# ADDENDUM #02

DATE: August 22, 2022  
 PROJECT: Sininger Hall – School of Business (RFP 23-002)  
 FROM: Baker Architecture + Design  
 TO: All Prospective Offerors

**AS-102**  
SHEET \_OF\_

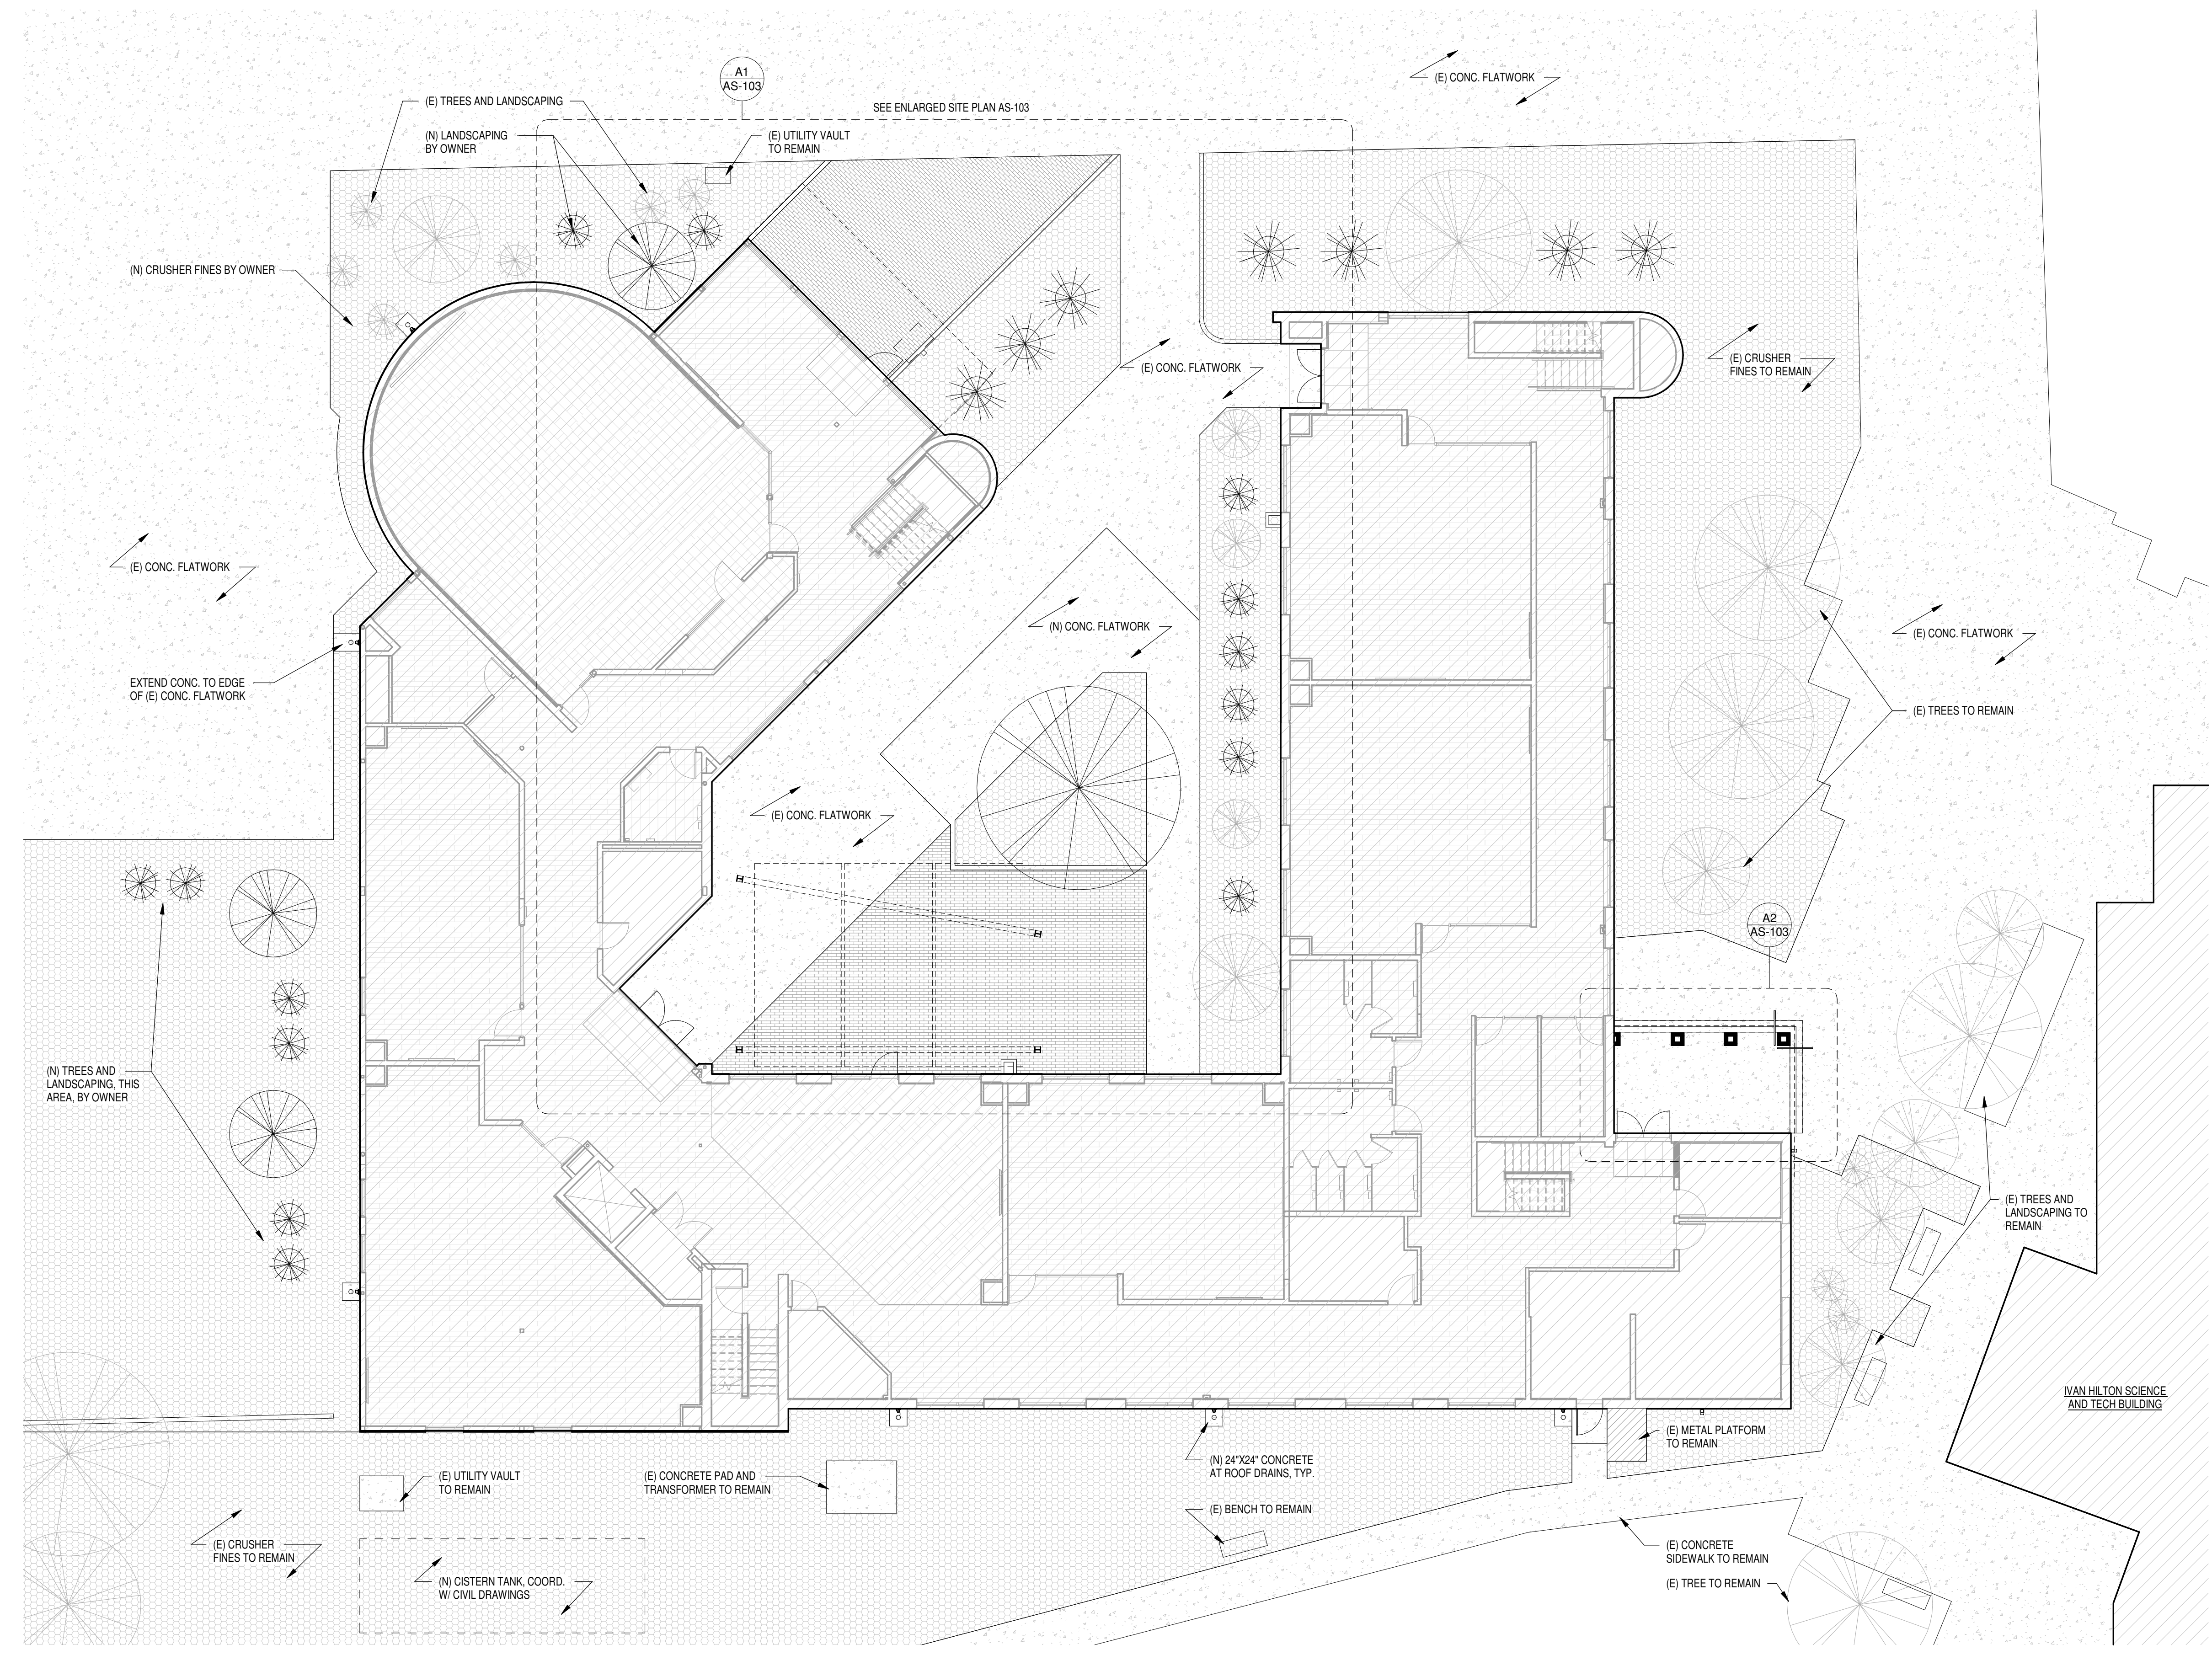
- 9) *"Sheet AS-102 general note 1 indicates GC to provide and install irrigation sleeving, please provide sheet with layout of where lines are to go."*

**Response: See updated AS-102 and AS-103, irrigation sleeving has been removed from project.**

Sheet AS-102 – Site Plan – Removed irrigation sleeve note  
Sheet AS-103 – Enlarged Site Plan – Removed irrigation sleeve note  
Sheet A-101 – First Floor plan – Updated room title from Electrical to Fire Riser Room  
Sheet A-601 – Door Schedule – Door 110 removed from schedule and replaced with Door 111  
Sheet A-603 – Finish Schedule – Resilient Base moved from GC to owner's scope

**AS-103**  
SHEET \_OF\_

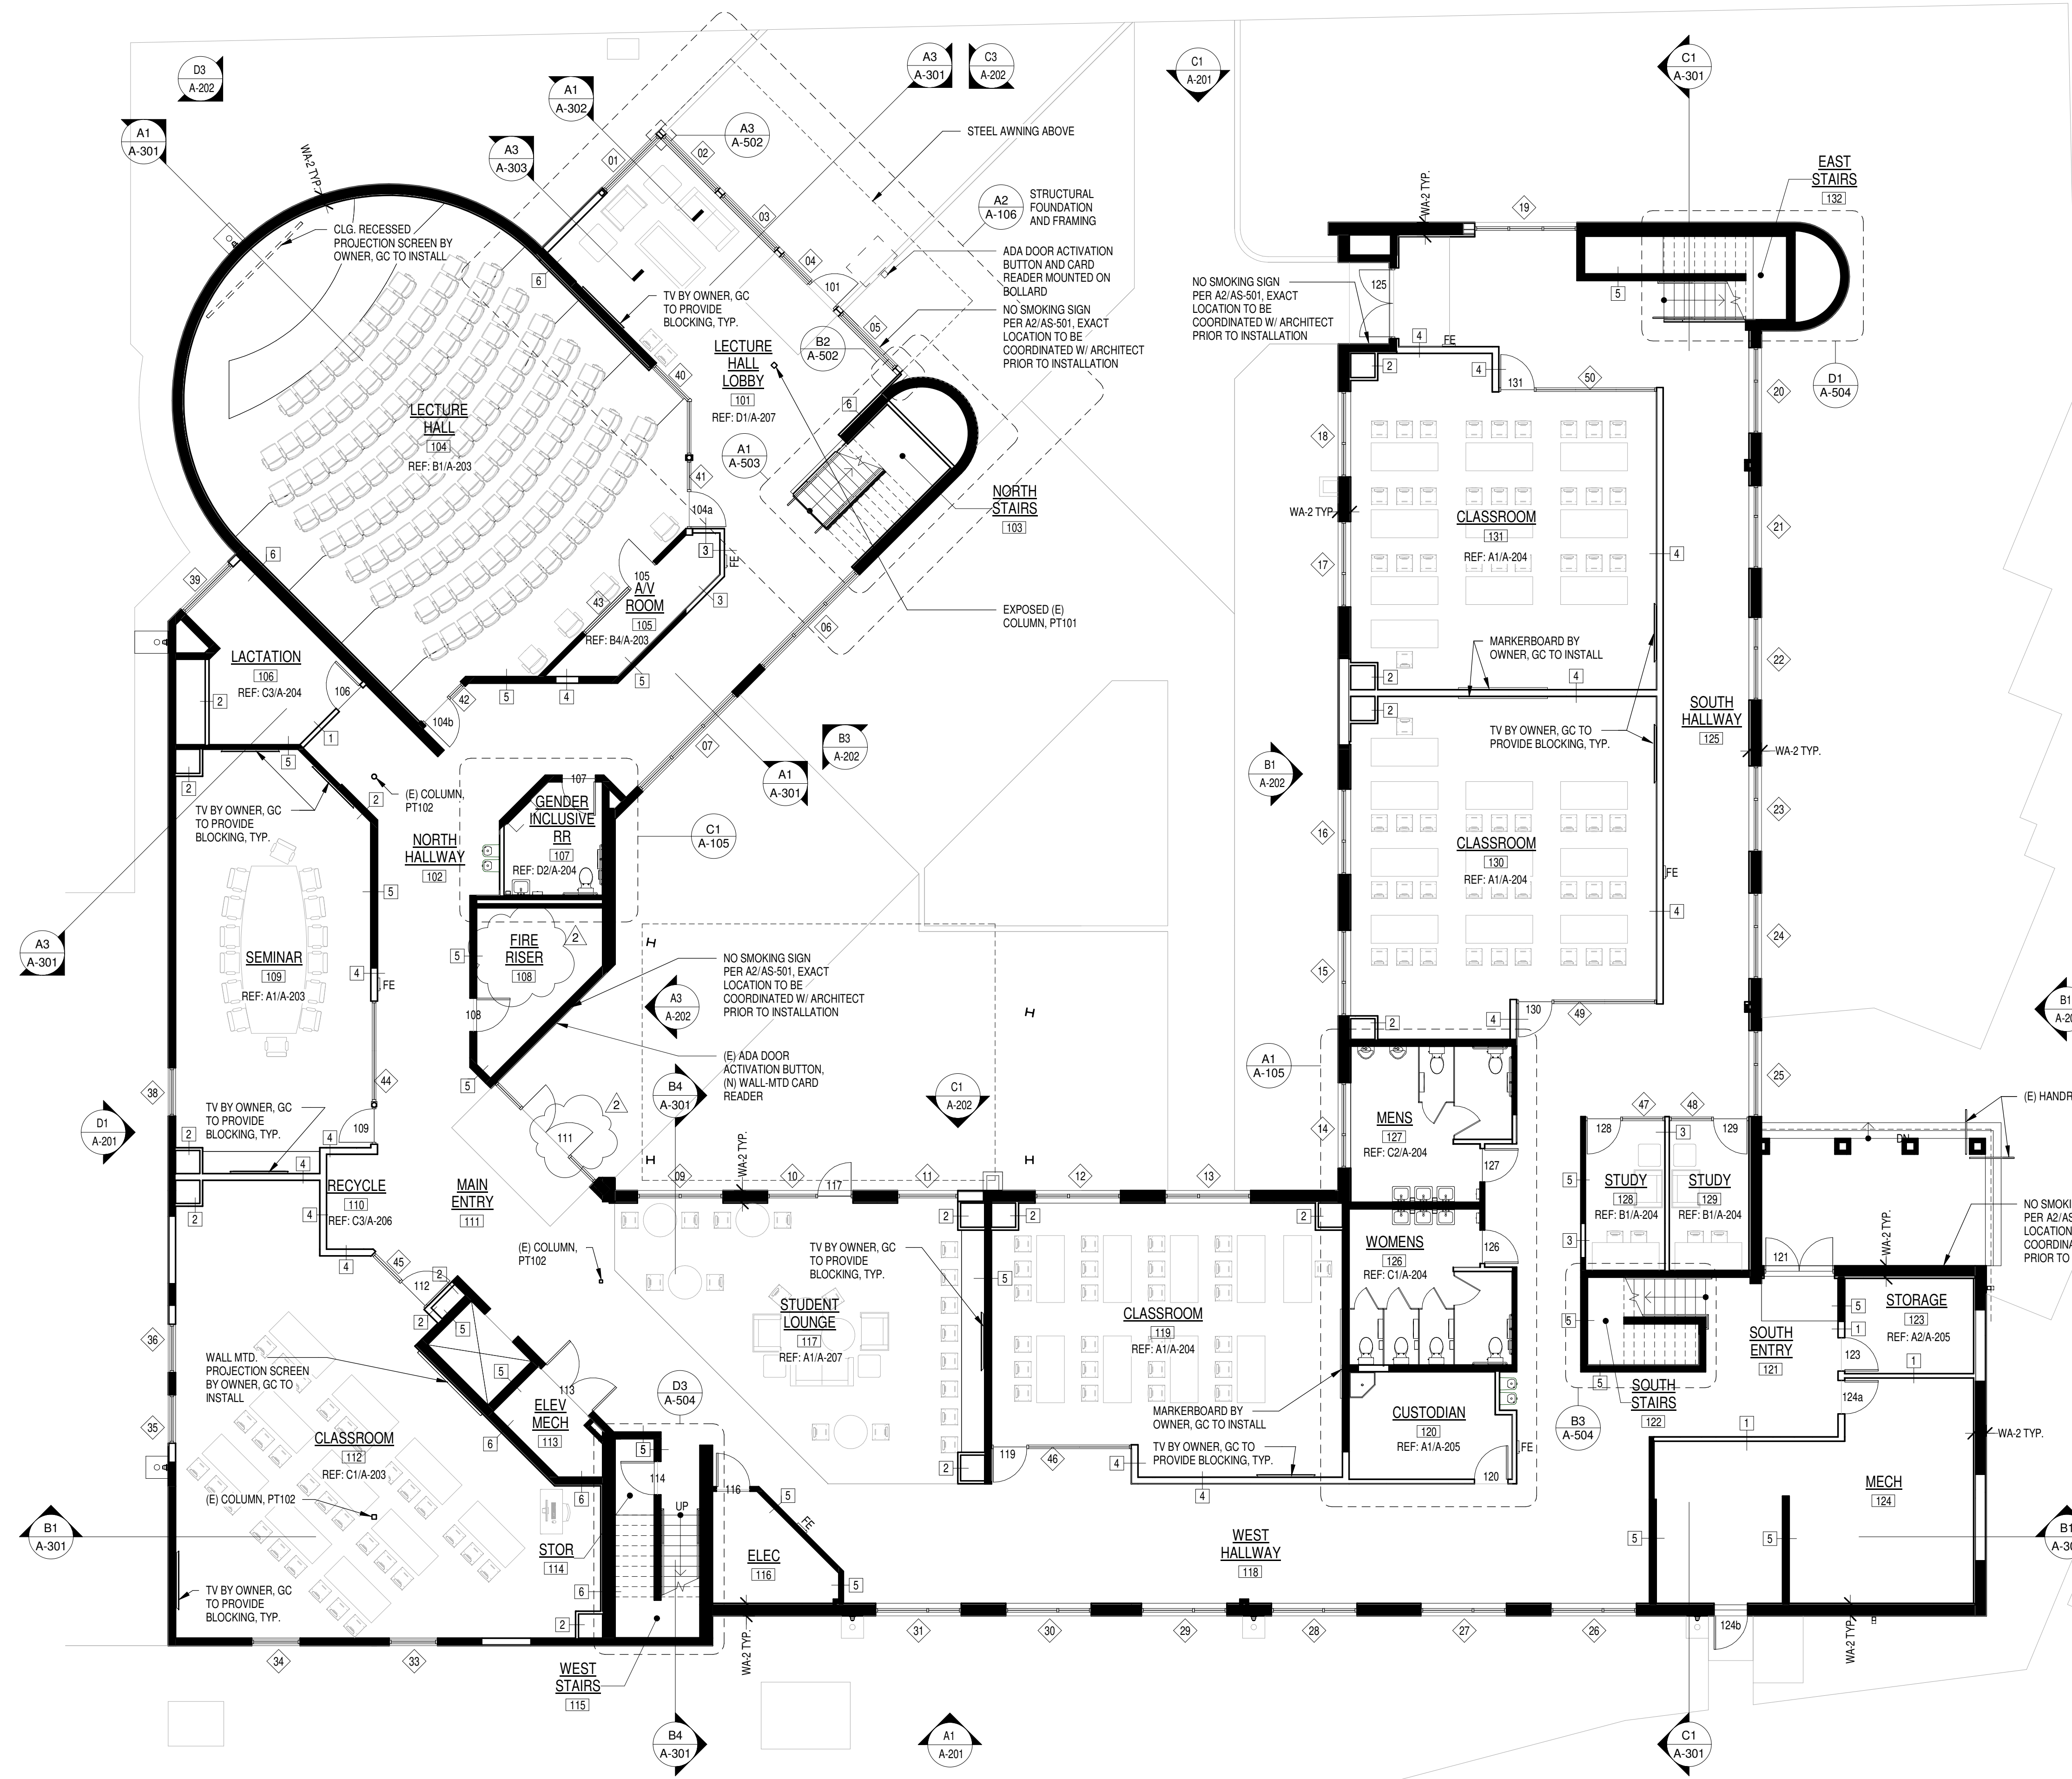
- 1) *“Sheet AS-103 indicates areas for brick pavers, are those part of the owners landscaping? Also is that to be included in base bid or bid lot #1?”*

**Response: This will be the responsibility of the selected GC, spec section 04 2110 Brick Pavers has been added to this addenda.**
